# KNIGHT CANCER RESEARCH BUILDING

## DESIGN ADVICE REQUEST NO. 2

24 SEPTEMBER 2015

DAR #1 REVIEW:

# MASSING & ARCHITECTURE: SOUTH ELEVATION STUDIES

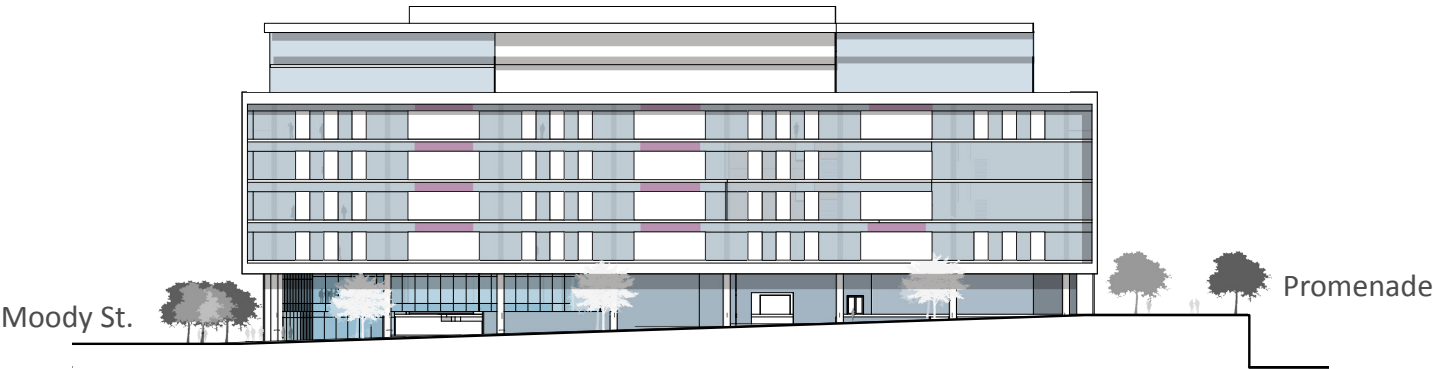
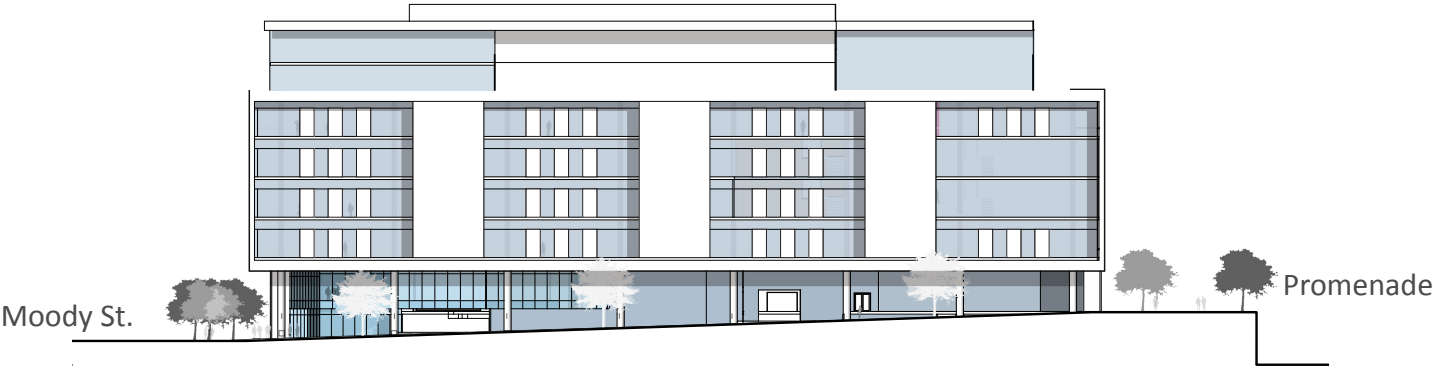
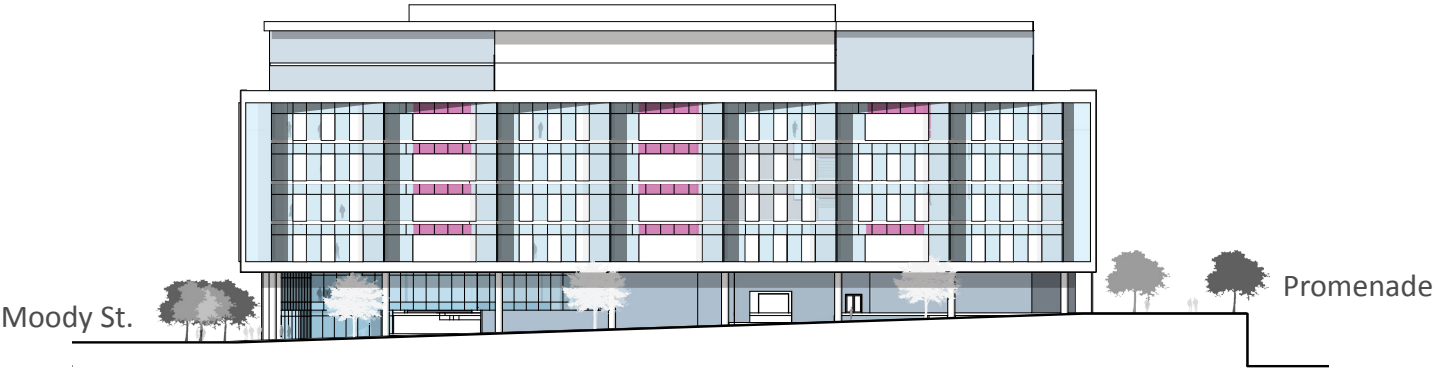
<div>Massing/Architecture</div> <div> <p>5. Due to the length of the property Commission has reservations about a <b>relentless form, expanse of glass</b>, and the <b>large overhang</b>.</p> <p>6. The building should incorporate <b>operable windows and terraces</b> for 3 reasons – <b>both elements break up a very long façade of glass</b>, they <b>enliven the neighborhood</b>, and they are <b>critical for providing a humane working environment</b>.</p> <p>7. In order to support the Modifications, the Commission will pay particular attention to the <b>views and experience from the sidewalk</b> and <b>exceptional architecture</b>.</p> <p>8. Have you considered <b>what happens to the north side uses</b> when Phase II happens? The North side will lose all light. Should the north side programming move to the south side to break up the south side?</p> <p>9. Tell us more about what happens inside and how it informs the outside.</p> </div>	<div>Massing/Architecture</div> <div> <p>5. <i>The south elevation has been refined to animate the street presence, capture primary site views, reduce glazing, and respond to solar orientation. The ground level overhang is consistent with the overall building scale and provides an inviting and partially-protected pedestrian experience. (See “Massing and Architecture” section for specifics.)</i></p> <p>6. <i>Providing neighborhood interest and a humane/ collaborative work environment are fundamental project objectives. Operable windows at open office locations are being investigated and the terrace feature is consolidated at the 6th floor. Neither of these features, however, are feasible within the lab and lab support areas.</i></p> <p>7. <i>Providing a distinctive visual and neighborhood presence is a major design intent, especially from the pedestrian/sidewalk experience; and the design seeks the level “exceptional architecture” -- a high priority for OHSU, the Knight, and the design-construction team. (See “Active Street and Neighborhood” section for additional images and views.)</i></p> <p>8. <i>The north side of the building is challenging, both in the interim and final configurations. Access to natural daylight will be preserved under all conditions and the opportunity to encourage an exciting and integrated expansion is desired. A special re-evaluation of the building organization was undertaken with unanimous support to retain the current alignment.</i></p> <p>9. <i>More complete information regarding the building function and organization is described, including its direct impact on the exterior building design. (See “Massing and Architecture” section for detail.)</i></p> </div>

West End of South Elevation

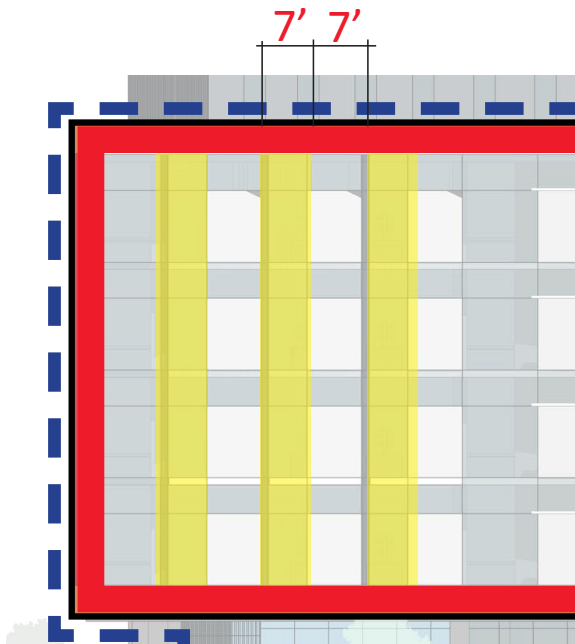
## ■ Section OSSC/32/#1 - Q2, 6

Request spacing between projecting window elements from 12' to 7'

East End of South Elevation

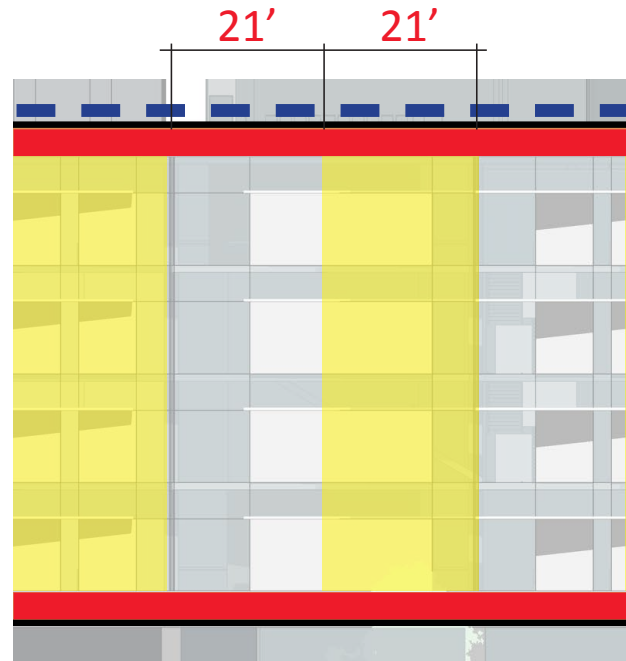
## ■ Section OSSC/32/#1 - Q2, F

Request spacing of 21' for projection

# DESIGN ADJUSTMENTS: LOADING DOCK

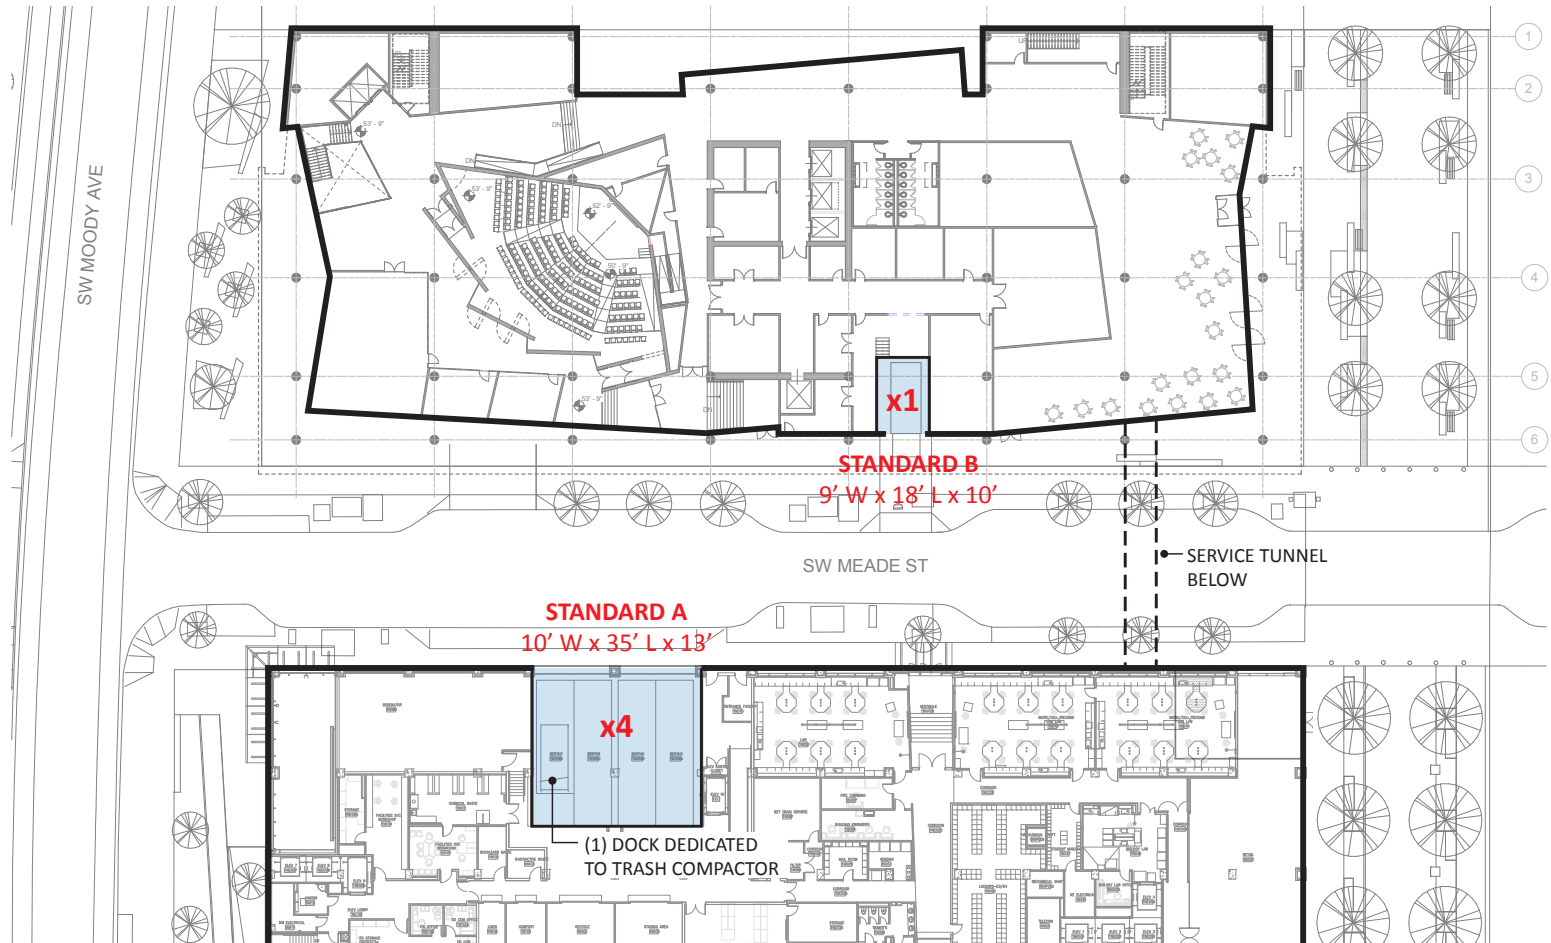
<div>Service</div> <div> <p>1. The time to <b>interconnect parking and loading functions in a central location</b>, preferably underground, is NOW. This is a campus that is in its infancy. Campuses should share functions. There was strong suggestion to <b>look to CLSB for sharing loading and/or parking</b>. The Commission will not support each building standing on its own and each having its own service areas.</p> </div>	<div>Service</div> <div> <p>1. <i>The building’s parking and service issues have been consolidated with existing CLSB uses and capacities; and an integrated campus service/distribution system has been identified, thereby reducing the KCRB service to a single dock. (See “Active Street and Neighborhood” section for proposed scope and alignment.)</i></p> </div>
<div>Ground Level</div> <div> <p>2. The <b>ground level should be active</b>. However, have you considered uses other than retail – uses that <b>offer the researchers a break</b> from their many hours spent in the lab?</p> <p>3. <b>This building makes a neighborhood</b> – people need services other than coffee shops.</p> <p>4. Next time show sections through the building that indicate the floor levels in relation to the sidewalk grade.</p> </div>	<div>Ground Level</div> <div> <p>2. <i>We fully endorse active ground functions and are focusing on uses that support the building’s research focus, its users and the general public. The café on the promenade is intended to highlight healthy life-style menus; and a range of active uses are proposed at the Moody location.</i></p> <p>3. <i>The building design reinforces the unique characteristics of an “urban academic-research campus” and differs in character and intensity from more conventional commercial/residential and commercial/retail neighborhoods.</i></p> <p>4. <i>Additional building sections and diagrams are provided to clarify the proposed design conditions and intent. (See “Active Street and Neighborhood” and “Design Modifications” sections for more specific information.)</i></p> </div>

## ■ Section 33.266.310

Adjustment from (2) Standard A to (1) Standard B for special lab support.
